ADMINISTRATIVE AMENDMENT

1 SITE PLAN FOR ADMIN. AMENDMENT

HANOVER STUDIOS
6500 HANOVER RD NW
ALBUQUERQUE, NM 87121

SHEET TITLE
SITE PLAN FOR ADMINISTRATIVE AMENDMENT

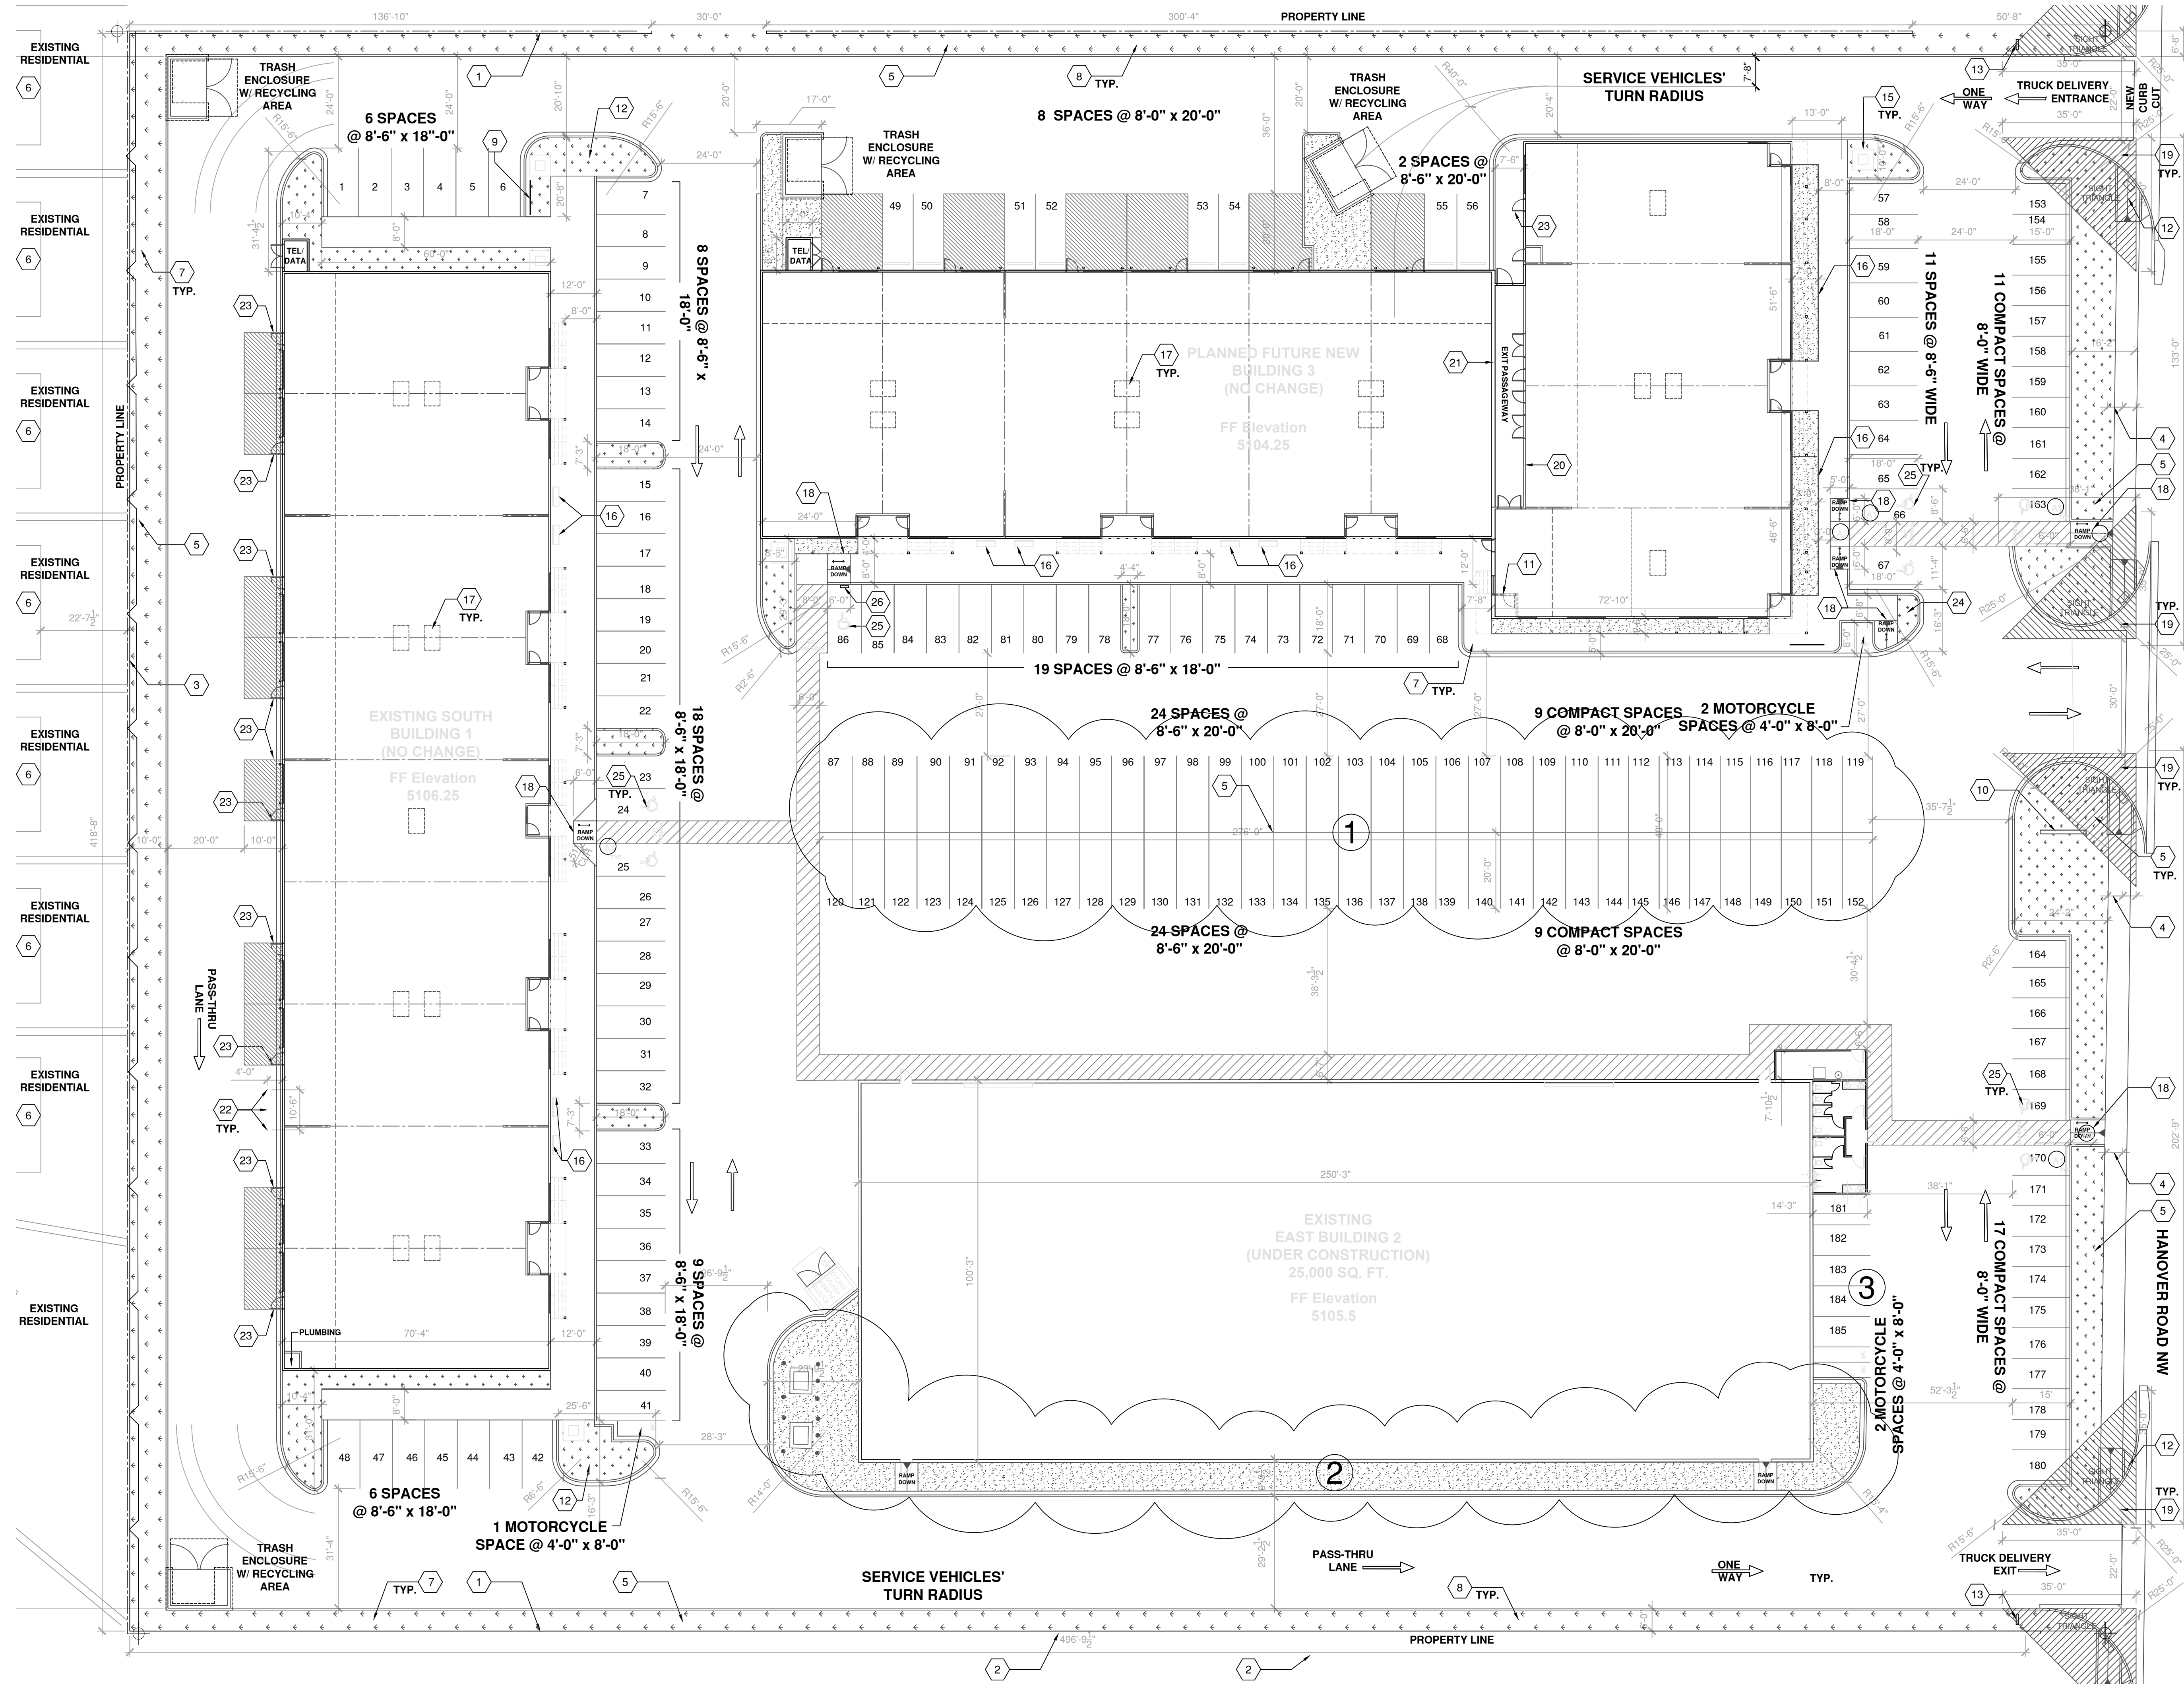
- ALL NEW RAMPS SHALL BE PER C.O.A. STANDARD DRAWING 2440/2441
 - LANDSCAPING AND SIGNAGE WILL NOT INTERFERE WITH CLEAR SIGHT REQUIREMENTS.
- CHANGES FROM ORIGINAL SP**

- REMOVAL OF EXISTING MEDIAN.
 - NEW LANDSCAPED AREA.
 - NEW PARKING SPACES.
- KEY NOTES**
- 6'-0" HIGH CMU SITE WALL PER SPECIFICATIONS AND DETAIL 3 / A-501.
